Tennessee Valley Authority, 1101 Market Street, LP 5A, Chattanooga, Tennessee 37402-2801

May 2, 2008

NUCLEAR REGULATORY COMMISSION (NRC) – BELLEFONTE NUCLEAR
PLANT (BLN) – RESPONSE TO ENVIRONMENTAL REPORT (ER) SUFFICIENCY
REVIEW COMMENTS

RESPONSE TO ENVIRONMENTAL REPORT SUFFICIENCY REVIEW

**Bellefonte Nuclear Plant
COLA Part 3, Environmental Report
Figure 2.3-X1
Recreational Sites within a Six-Mile Radius**

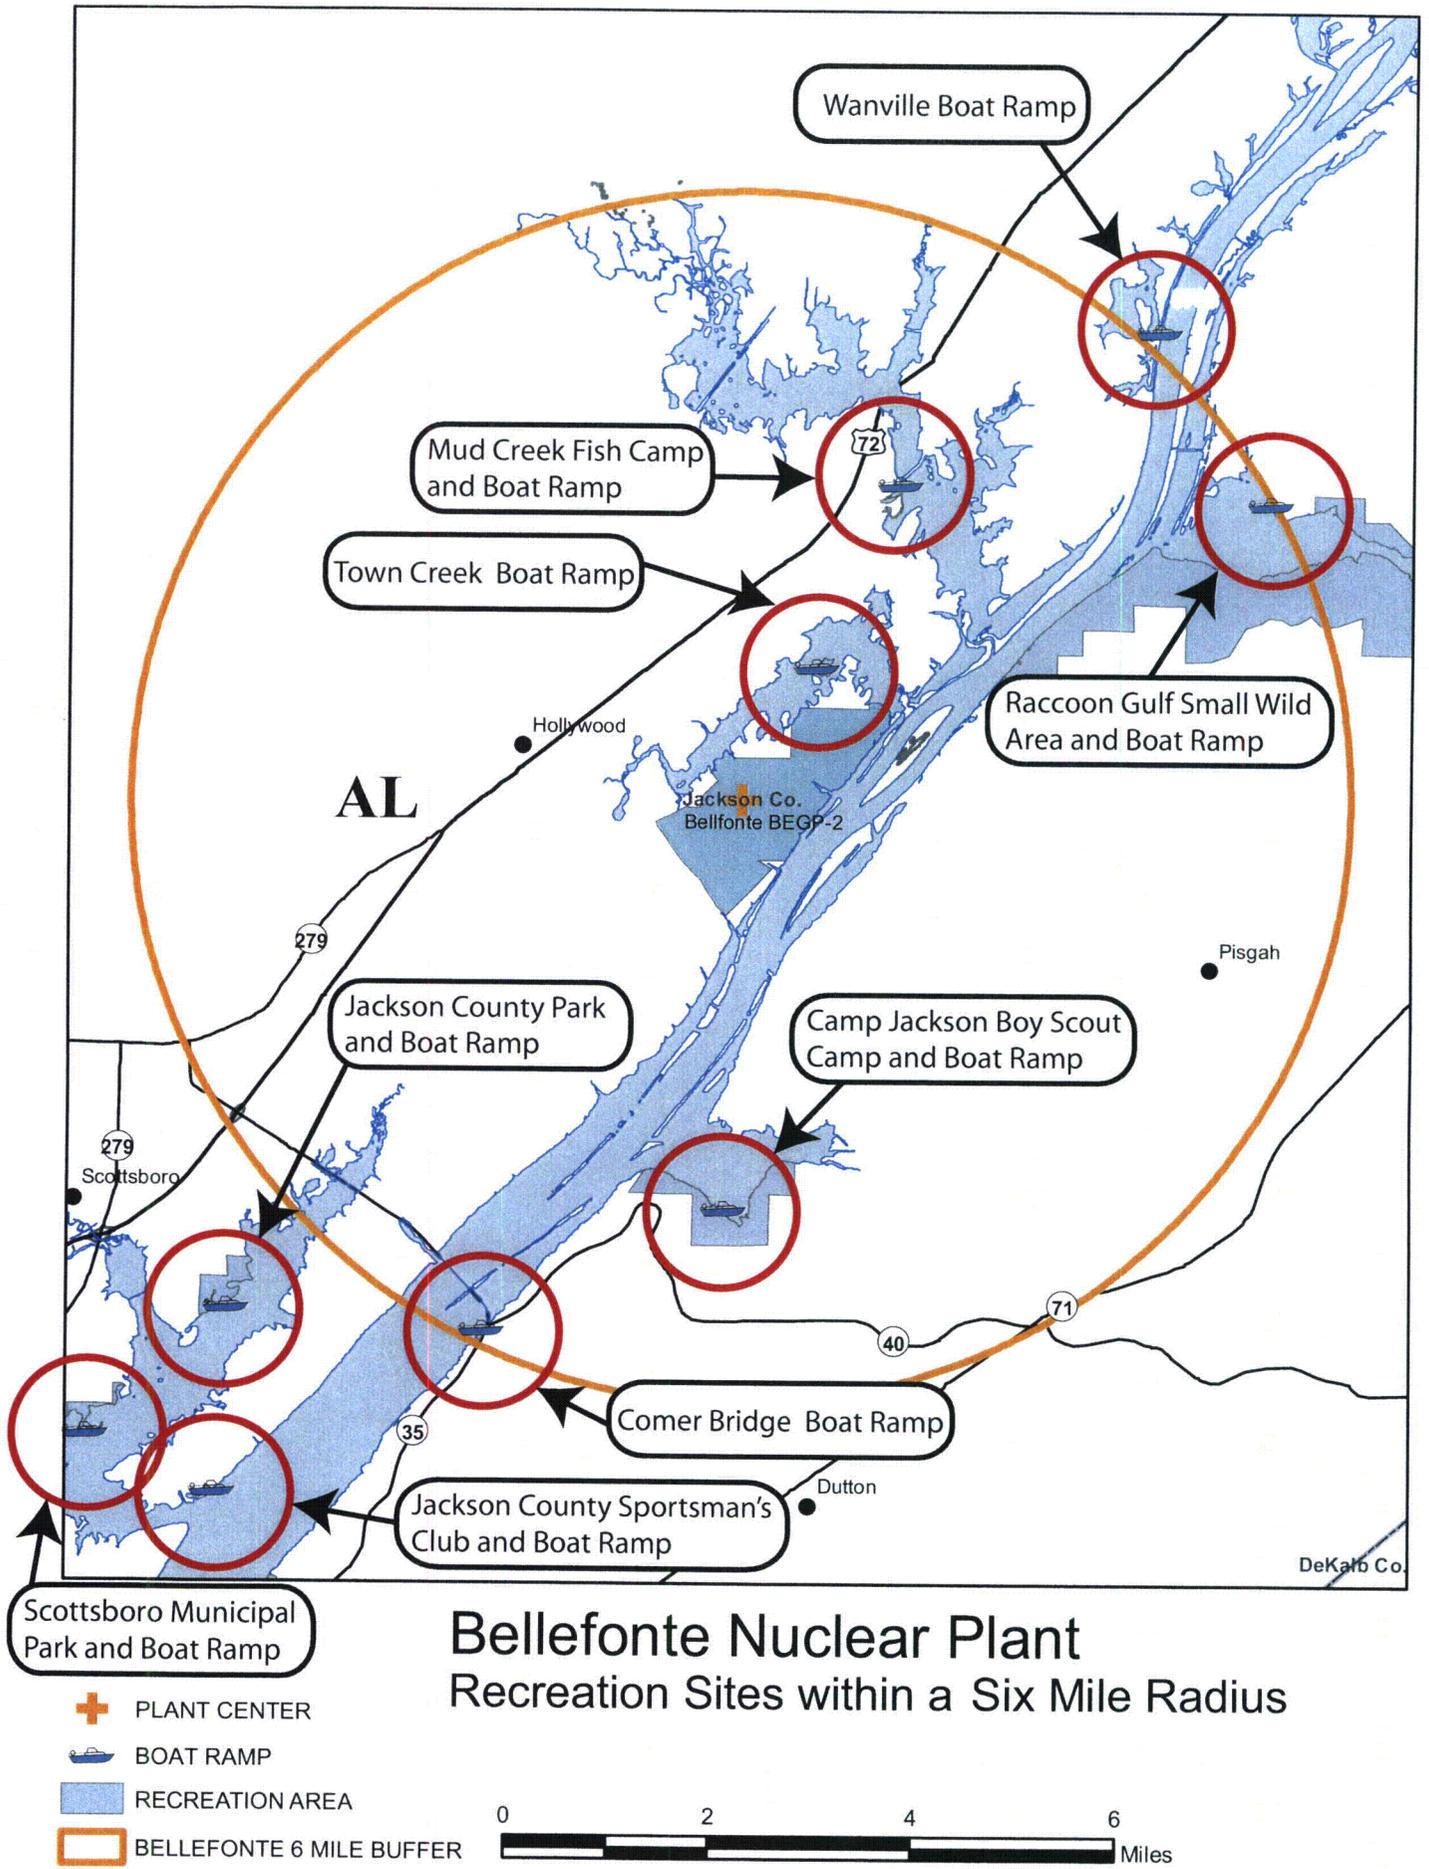
Lakes and impoundments detailed bathymetry data base may not be present in the references. The color shaded and contoured map (Section 2.3.1.2.5, Figure 2.3-9) may not be sufficient, and a data base of the bathymetry data may be required to support analyses and the creation of maps and figures in the EIS.

Six recreation areas and boat ramps are located within the vicinity of the BLN site: Wanville Ramp (6 mi. upstream), Raccoon Gulf Small Wild Area and Ramp (5.5 mi. upstream), Mud Creek Fish Camp and Ramp (4 mi. upstream), Town Creek Ramp (2 mi. upstream); Camp Jackson Boy Scout Camp and Ramp (4 mi. downstream), and Comer Bridge Ramp (6 mi. downstream). Boat ramps and fishing access are also available within 10 river mi. at Jackson County Park, Jackson County Sportsman's Club, and Scottsboro Municipal Park (Figure 2.3-X1).

3. Revise COLA Part 3, ER Chapter 2, Section 2.3, by inserting **Figure 2.3-X1**, Recreational Sites within a Six-Mile Radius, near the end of the chapter.
